MAJOR PROJECT ASSESSMENT:

188 marina berths and associated workshop/maintenance and club facilities; 150 accommodation units (75 tourist and 75 residential); restaurant, café, function centre, shops and office; parking, landscaping and boardwalk. MP06-0309

Director-General's
Environmental Assessment Report
Section 75I of the
Environmental Planning and Assessment Act 1979

July 2009

Figure 2.4: Key Building Setbacks

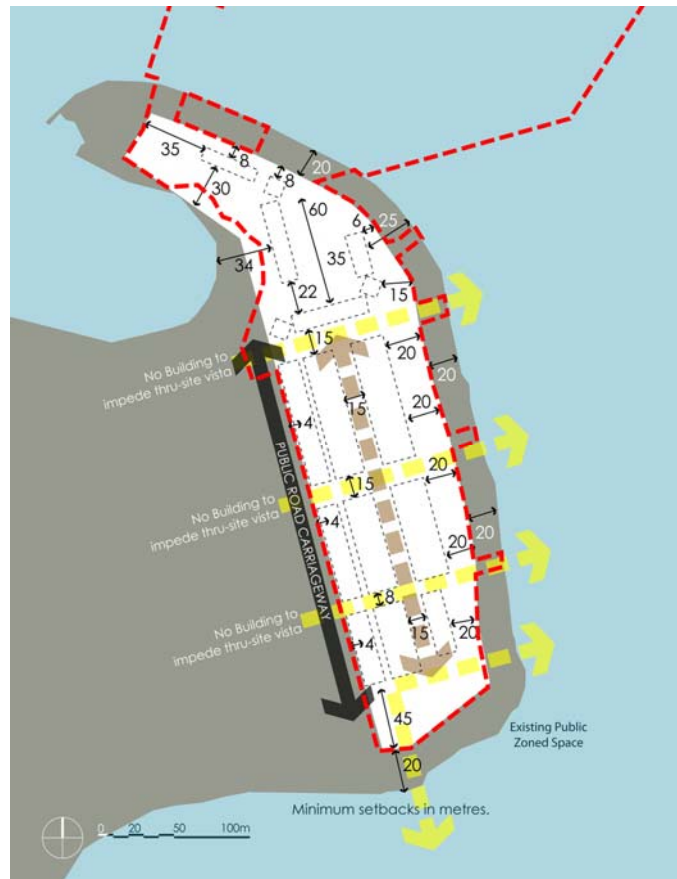
The setbacks shown in Figure 2.3 and their compliance with the relevant controls can be summarised as follows:

- A 4-metre building setback along Trinity Point Drive with the exception of the intended accent Buildings. This 4 metre setback is compliant with DCP1 requirement of 4 metre setback for dwellings in newly developing areas. The accent buildings as shown in Figure 2.5 are to have the opportunity to build to the street edge subject to detailed design. This does not comply with the typical residential setback of 4 metres in newly developing areas. As stated the site is not zoned residential and there are no specific setback controls for the 6(2) Tourism and Recreation zone. As such a zero setback is allowable. The streetscape achieved by the accent buildings possibly having zero to 4 metre setbacks will provide variation and add to the character of the development. The detailed design will be critical in ensuring this outcome is acceptable. The Site Principle-Building Setbacks within the Concept Plan should be modified with the inclusion of an additional guideline stating that future application for buildings with a zero setback are to demonstrate a suitable level of detailing and articulation to ensure they add to, rather than detract from, the streetscape. Blank walls are to be avoided.

Figure 2.5: Building Heights (within the Piazza) Figure 2.6: Building Heights (Outside the Piazza)

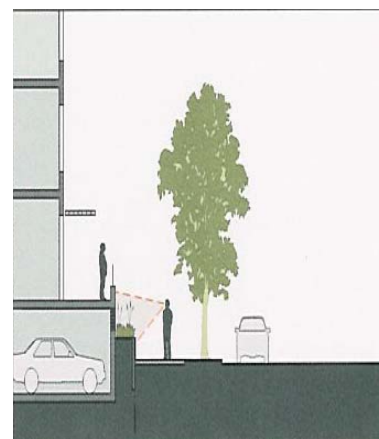
The heights shown in Figure 2.5 (within the Piazza area), and their suitability can be summarised as follows:

- 4 storey plus pitched roof form - northern accent building which consists of parking at ground, restaurant at piazza level, 2 storeys of residential plus pitched roof form (shown in dark blue in figure 2.5);
- 4 storey plus pitched roof - buildings on the western and southern edge of the piazza which consist of parking at ground, function centre and retail/commercial at piazza level, 3 storeys of residential one of which is included within the pitched roof form (shown in pink in figure 2.5);
- 3 storey plus pitched roof form - building on eastern edge of piazza which consists of parking at ground (under half the building) café at ground adjoining the pathway split level so it also adjoins the piazza level, plus 2 levels of residential one of which is contained within the pitched roof form (shown in orange in figure 2.5); and

- 5 storey plus pitched roof form - remaining 2 accent buildings which consists of parking at ground, retail/business centre at piazza level, 3 storeys of residential and a pitched roof form (shown in light blue in figure 2.5).

- 2 storey marina building with a finished floor level of 1.2AHD (shown in olive green in figure 2.5) (natural ground is 1.0AHD). This is consistent with the typical height of buildings in the locality and is appropriate.

The heights shown in Figure 2.6 (outside the Piazza area) can be summarised as follows

- 1 storey plus pitched roof form with an option for a partially exposed parking structure, up to 1.2m fronting of Trinity Point Drive (southern section) (shown in pink in Figure 2.6). The site is adjoined to the west by Residential 2(1) zoned land which has a 2 storey (plus roof) height limit. The proposal is consistent with the residential scale in the area and is considered acceptable

- 2 storey plus pitched roof (with some building elements on a number of buildings to 3 storeys subject to detailed design and merit assessment) adjoining the setback area along the eastern side of the development and the section central to the site (shown in blue on Figure 2.6). This site is adjoined to the west by Residential 2(1) zoned land which has a 2 storey (plus roof) height limit. The proposal is consistent with the residential scale in the area and is considered acceptable
